UNITED STATES OF AMERICA  
NUCLEAR REGULATORY COMMISSION

In the Matter of )  
)  
)  
DTE ELECTRIC CO. ) Docket No. 52-033  
)  
)  
(Fermi Nuclear Power Plant, Unit 3) )

NRC STAFF RESPONSES TO COMMISSION PRE-HEARING QUESTIONS

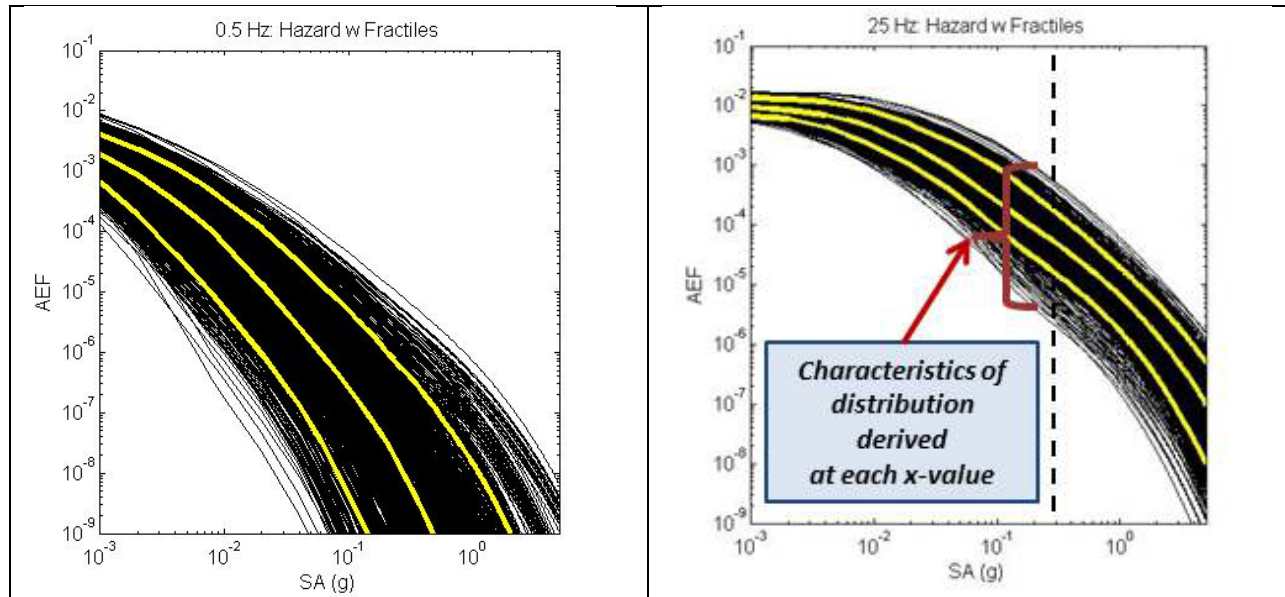
15. Subsection 2.5.2.4 of the FSAR describes the applicant's Probabilistic Seismic Hazard Analysis (PSHA) calculations for the Fermi Unit 3 site, including the generation of seismic hazard curves. These hazard curves show the probability of exceeding a certain ground motion level. For any given vibration frequency the hazard is given by a family of curves that account for uncertainty in the calculations. A behavior that has been observed to be common in these hazard curves is that this uncertainty varies significantly per vibration frequency. Explain how the potential implications of this observation were accounted for in determining whether the Fermi Unit 3 site meets the standard seismic design requirements in the DCD.

Figure Q-14a (below) illustrates this effect by utilizing a single representation of a seismic source zone impacting the Fermi 3 site. Black lines are individual seismic hazard curves calculated using alternative model parameters. Yellow lines indicate 5%, 50% (median), and 95% percentiles calculated from the distribution of the black curves at each x-value. Even though this is a result from a simplified model, the suite of seismic hazard curves shown for 0.5 Hz and 25 Hz frequencies demonstrate variable ranges in hazard (the y-axis) due to frequency-specific and variable impacts of different elements of the uncertainty model. Specifically, the hazard curves shown below in Figure Q-14a are for the base or very hard rock conditions at the Fermi 3 site. For this geologic setting, the hazard curves for the 25 Hz spectral accelerations, shown on the right, are higher, with smaller ranges of uncertainty for specific values of spectral acceleration, than the hazard curves for the 0.5 Hz spectral accelerations, shown on the left, which are lower and have larger ranges of uncertainty. This is primarily due to the larger number of postulated earthquakes over a wider range of magnitudes and distances in the region surrounding Fermi 3 being able to produce relatively high 25 Hz spectral accelerations. In contrast, not as many postulated regional earthquake scenarios for Fermi 3 are able to produce large 0.5 Hz spectral accelerations, which results in lower hazard curves with larger ranges of uncertainty for this lower spectral frequency.

For all ground motion frequencies, the mean hazard is directly derived from the uncertainty represented in the complete suite of hazard curves (such as those shown in the figure above with black lines). Thus, for each ground motion frequency, the mean hazard incorporates the uncertainty included in the seismic source characterization and ground models and the use of the target MAFE is consistent with achieving the performance goals and seismic margins inherent in RG 1.208.

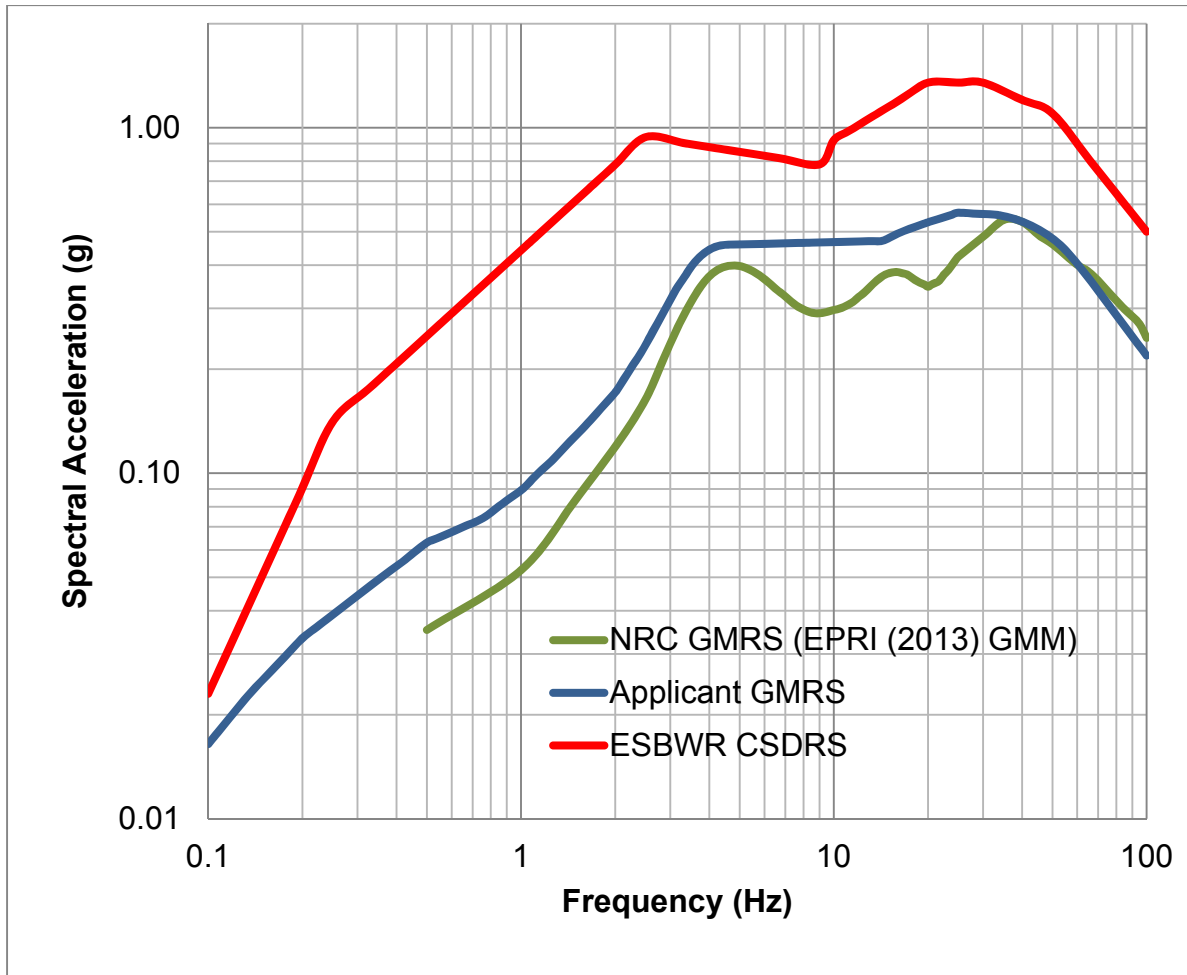
- 29. To address Near Term Task Force (NTTF) Recommendation 2.1, the Staff requested the applicant to evaluate the potential impacts of the NUREG-2115 seismic source model on the Fermi Unit 3 seismic hazard and to modify the site-specific ground motion response spectra (GMRS) and foundation input response spectra (FIRS) as necessary. In response, the applicant updated its PSHA and respective GMRS and FIRS reflecting the use of the NUREG-2115 seismic source model. In this update, the applicant used the Electric Power Research Institute (EPRI) 2004/2006 ground motion model (GMM). In 2013, EPRI published an update to the 2004/2006 ground motion model called the EPRI 2013 GMM. The EPRI 2013 GMM is currently being used by licensees in their assessments related to NTTF Recommendation 2.1. Describe how the Staff verified the adequacy of the use of the 2004/2006 EPRI GMM instead of the 2013 EPRI GMM to address NTTF Recommendation 2.1 for Fermi Unit 3.**

**Staff Response:** In response to RAI 01.05-1, the applicant provided an evaluation of the potential impacts of the NUREG-2115 seismic source model on the Fermi 3 seismic hazard, on March 15, 2013. The response included an updated Probabilistic Seismic Hazards Analysis (PSHA) with a revised Ground Motion Response Spectra (GMRS) and Foundation Input Response Spectra (FIRS). The applicant's revised GMRS and FIRS utilized the new NUREG-2115 seismic source model and the Electric Power Research Institute (EPRI) 2004/2006 ground motion model (GMM). An updated version of the EPRI 2004/2006 GMM (EPRI 2013) was later endorsed by the NRC on August 28, 2013 (ADAMS Accession No. ML13233A102).

Subsequent to finalization of its technical input to Section 2.5 of the Fermi SER, the staff conducted additional confirmatory analysis, to directly compare the site-specific seismic hazard results obtained using the EPRI 2004/2006 GMM with those obtained using the updated EPRI (EPRI 2013) GMM. These results confirm that, for the Fermi 3 site, the updated EPRI (EPRI 2013) GMM produces generally lower seismic hazard results than the EPRI 2004/2006 GMM. These confirmatory analysis results are shown in the figure below as the green curve labeled "NRC GMRS". The blue curve labeled "Applicant GMRS" is DTE's hazard results calculated using the EPRI 2004/2006 GMM. These results continue to indicate that DTE's use of the EPRI 2004/2006 GMM is conservative, and therefore acceptable.
